RESOLUTION NO. 1000

A RESOLUTION OF THE CITY COUNCIL OF THE CITY OF GIG HARBOR, WASHINGTON, AMENDING THE WASTEWATER COMPREHENSIVE PLAN BY REVISING THE SEWER COLLECTION BASIN BOUNDARY BETWEEN SEWER COLLECTION BASINS #10 AND #11.

REVISIONS	 <p>PUBLIC WORKS DEPARTMENT</p> <p>3510 Grandview Street Gig Harbor, WA 98335 (253) 851-6170 www.cityofgigharbor.net</p>	DESIGNED BY: DRAWN BY: CHECKED BY: APPROVED BY: SCALE: OTHER:	<p>WASTEWATER COMP PLAN AMENDMENT - BASIN No. 10 AND 11</p>	JOB NO. -	DRAWING NO. X

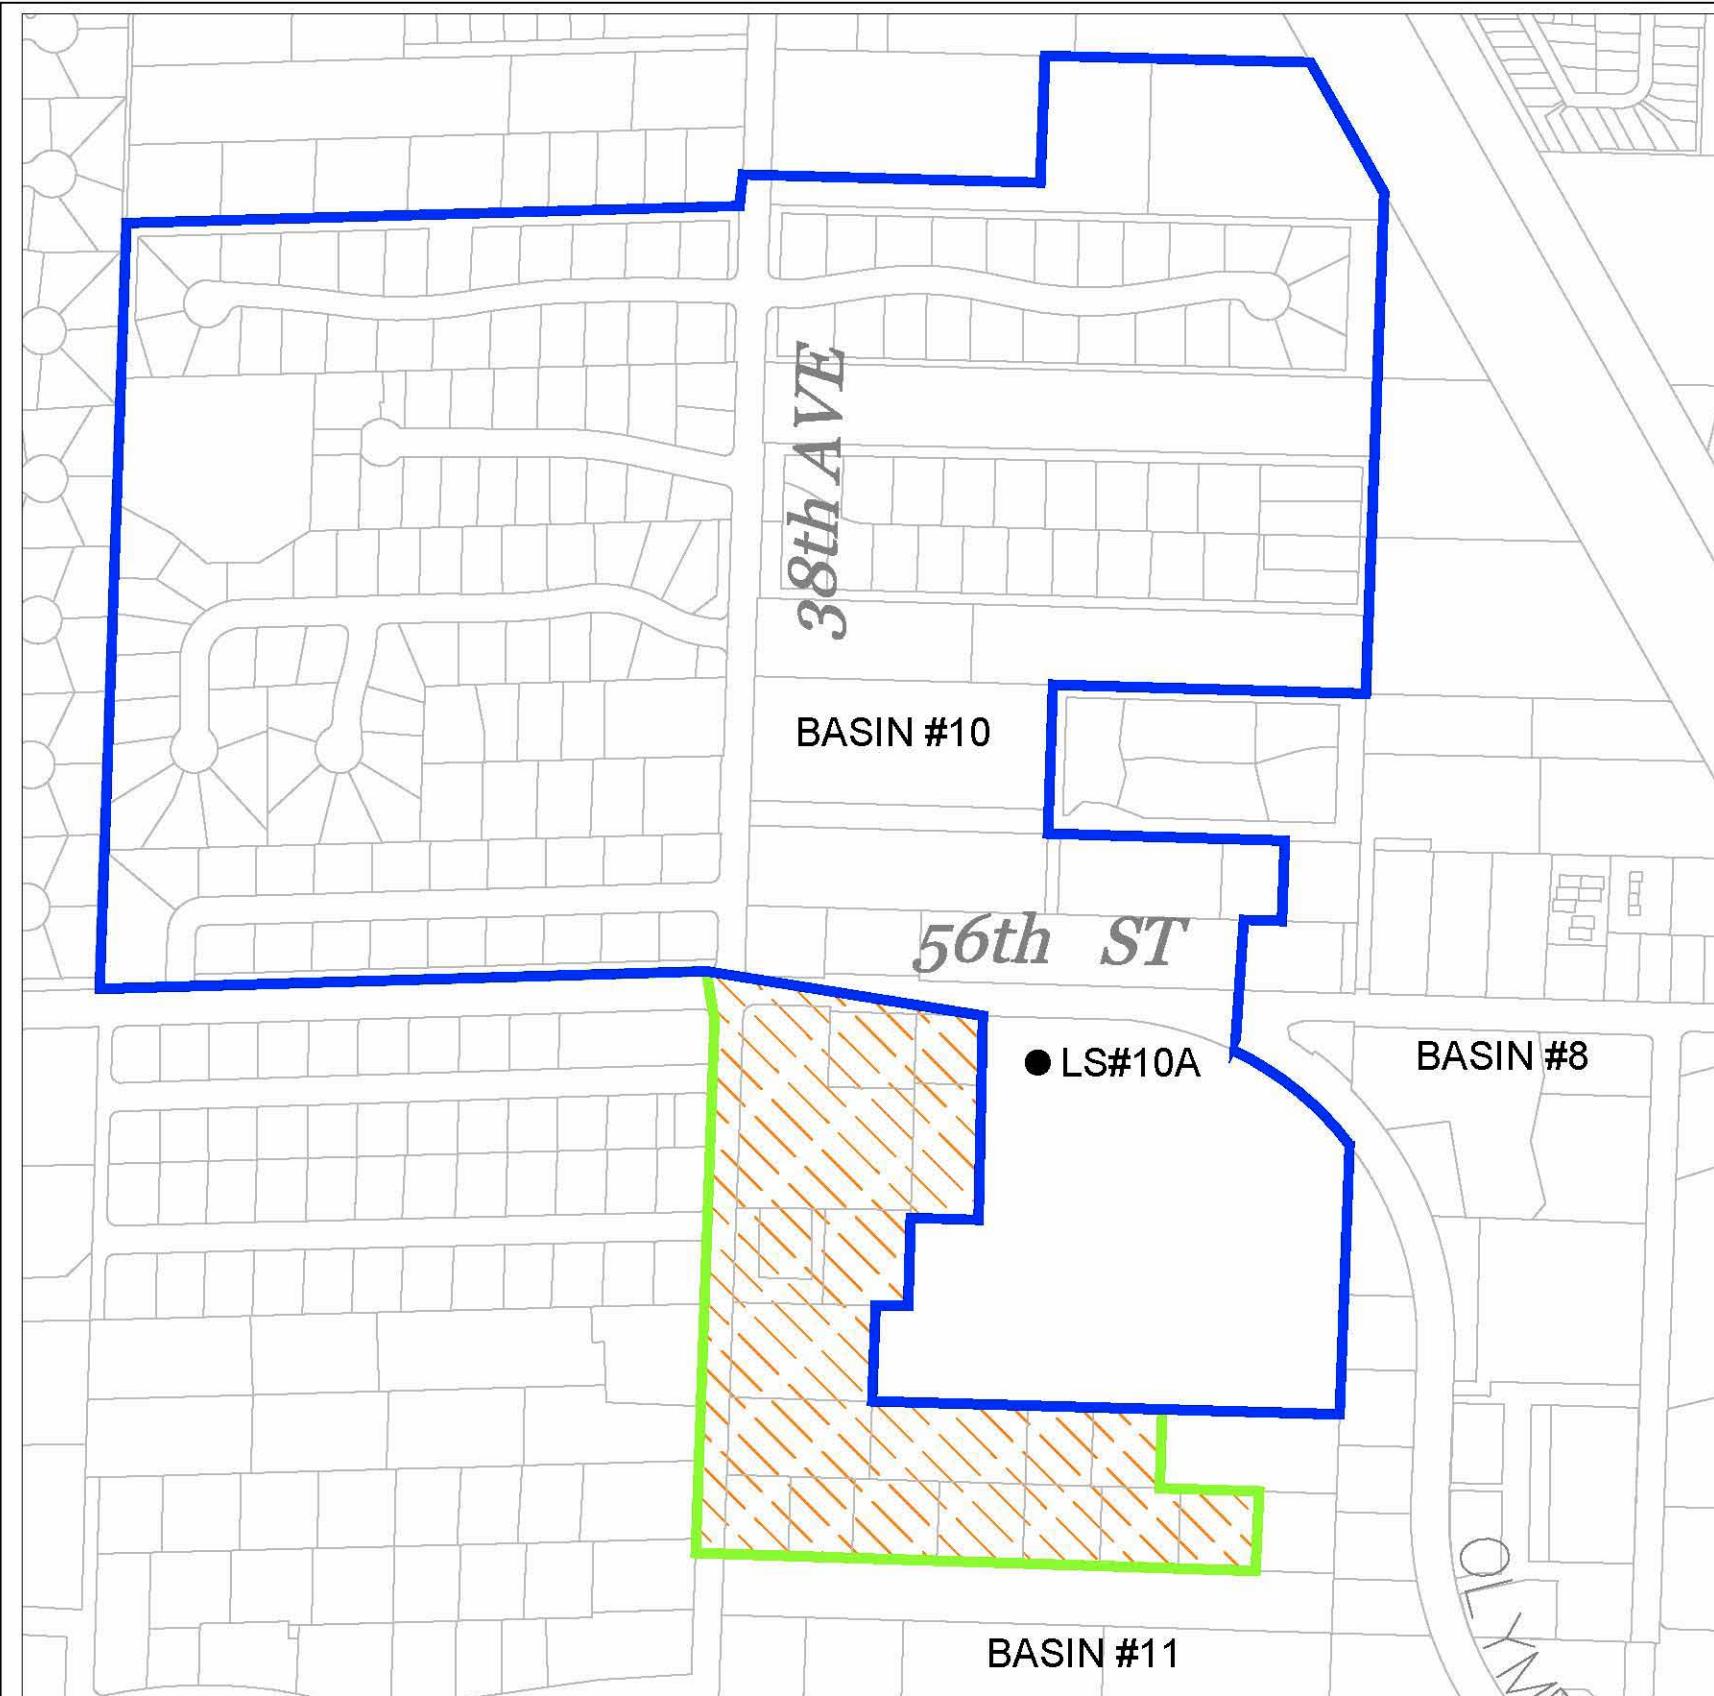
WHEREAS, the Public Works Department requests the boundary between sewer basins #10 and #11 be amended to transfer approximately 17 acres from sewer basin #11 to sewer basin #10 because sewer basin #10 is more likely to be developed in the near future due to lower sewer development expenses and more developable land; and

WHEREAS, both sewer basin #10 and sewer basin #11 will discharge to sewer basin #8, therefore sewer flow rates to downstream sewer infrastructure would not be altered by the proposed technical amendment; and

Section 1. Appendix B of the WWCP shall be amended to reflect the revisions to the Wastewater Basin Map as provided in the attached Exhibit "A".
